TEL: 91-11-24632950 Extn: 2219/2233 AFS: VIDDYXAX FAX: 91-11-24615508 E_mail:- <a href="mailto:gmais@aai.aero">gmais@aai.aero</a>	INDIA AERONAUTICAL INFORMATION SERVICES AIRPORTS AUTHORITY OF INDIA RAJIV GANDHI BHAVAN SAFDARJUNG AIRPORT NEW DELHI – 110003	39 / 2009
		23 <sup>rd</sup> September 2009

[EFFECTIVE DATE: 19 NOVEMBER 2009]

**SUB :- Amendment to VOR (Y) procedure RWY 06 - Raipur Airport.**

RAIPUR  
INDIA  
VOR(Y) RWY 06  
(Cat.A/B&C)

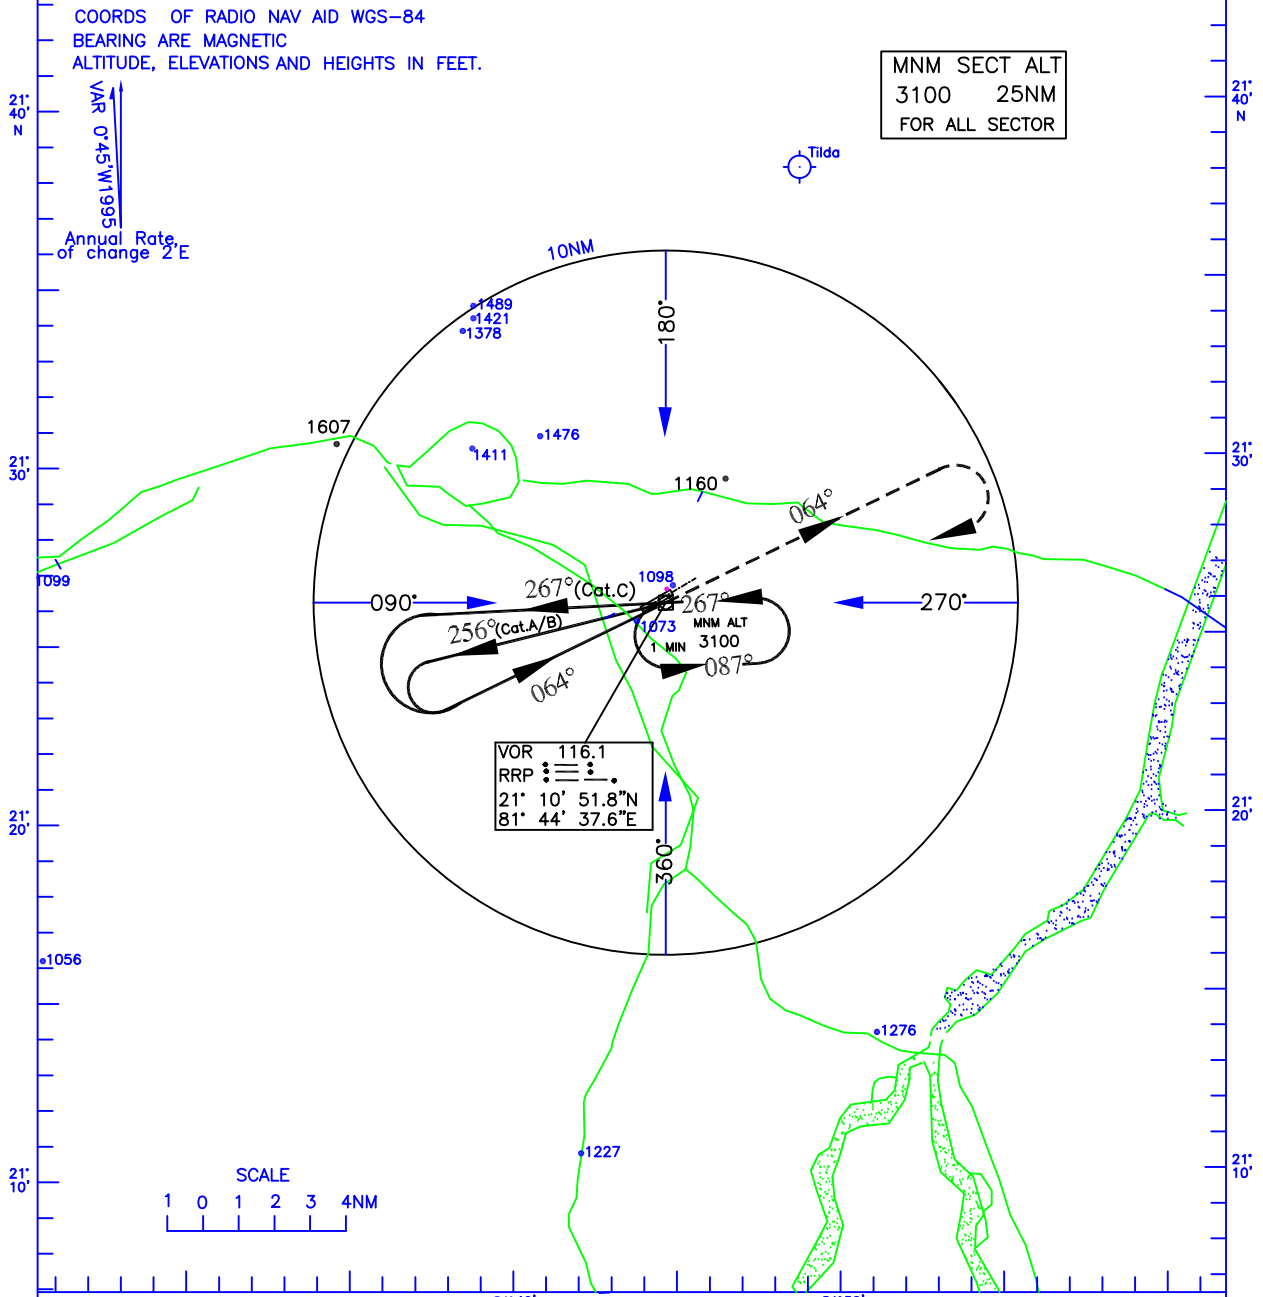
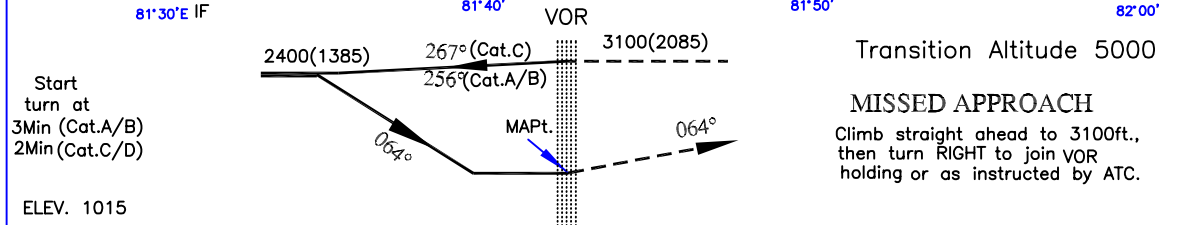
1. The following amendments are made in the VOR (Y) procedure RWY 06- Raipur Airport.
  - i) Minimum sector altitude (MSA) and Minimum holding altitude (MHA) are amended as 3100ft. in place of 2700ft.
  - ii) In the missed approach procedure the minimum altitude is amended as 3100ft. in place of 2700ft.
2. The instrument approach chart has been updated by including the amendments as specified at para 1.
3. Cancellation: AIP INDIA 6<sup>th</sup> edition Page AD2- VARP 11 dated 1 August 2007
